PIC16C62B Rev. A Silicon Errata Sheet

The PIC16C62B (Rev. A) parts you have received conform functionally to the Device Data Sheet (DS35008A), except for the anomalies described below.

FIGURE 1: $\overline{\text{MCLR}}$ EXTERNAL CIRCUIT

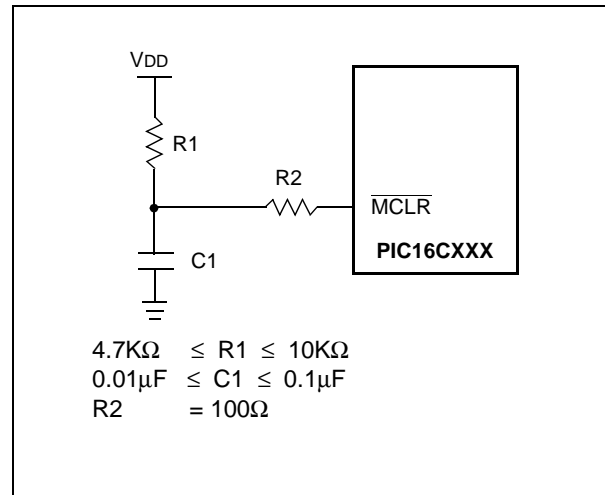
The minimum specification for the $\overline{\text{MCLR}}$ must be met in order to RESET the PIC16CXXX. If a $\overline{\text{MCLR}}$ pulse occurs that is less than the minimum specification (parameter #30), improper device operation can occur.

If the minimum specification cannot be met, then an external circuit must be used to insure that any pulse width less than the specification will be filtered before it reaches the $\overline{\text{MCLR}}$ pin.

A possible circuit is shown in Figure 1. Proper design validation needs to be done to ensure desired operation over the applications operating conditions

Figure 1: Wake-up from Sleep

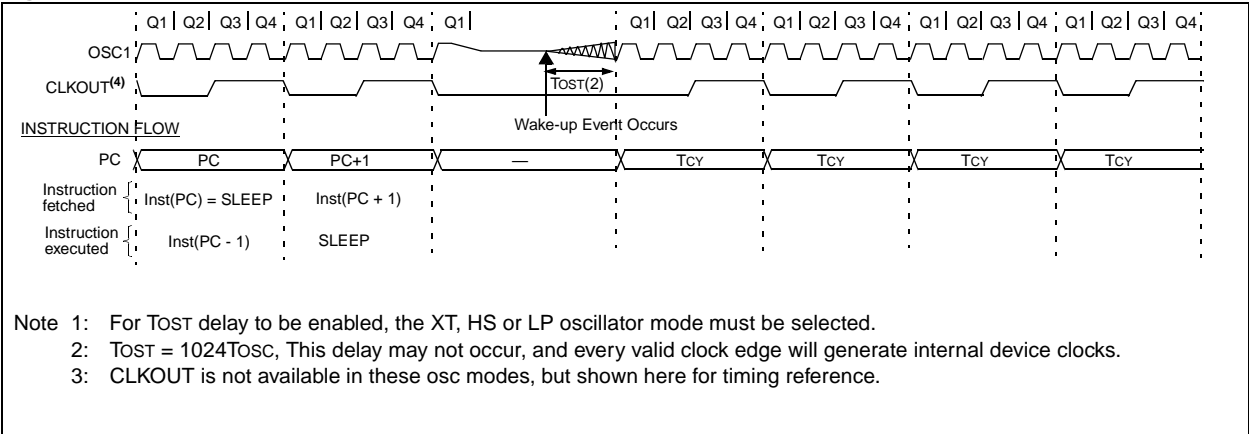
The Oscillator Start-up Timer (TOST) delay may not occur when the device wakes-up from sleep.

Figure 1 shows the start-up of the crystal after the event that causes the device to wake up from sleep mode (as specified in device data sheet). The start-up time (TOST) may not occur.

In applications where time based measurements are started immediately after wake-up from sleep, the suggested work around should be implemented.

After the SLEEP instruction, do a software delay of 256 Tcy (same as 1024 TOSC). At the Reset and Interrupt vector addresses, test to see if the device woke from sleep (the $\overline{\text{TO}}$ and $\overline{\text{PD}}$ bits), and if the device did wake from sleep, ensure that the total cycle delay is 256 Tcy.
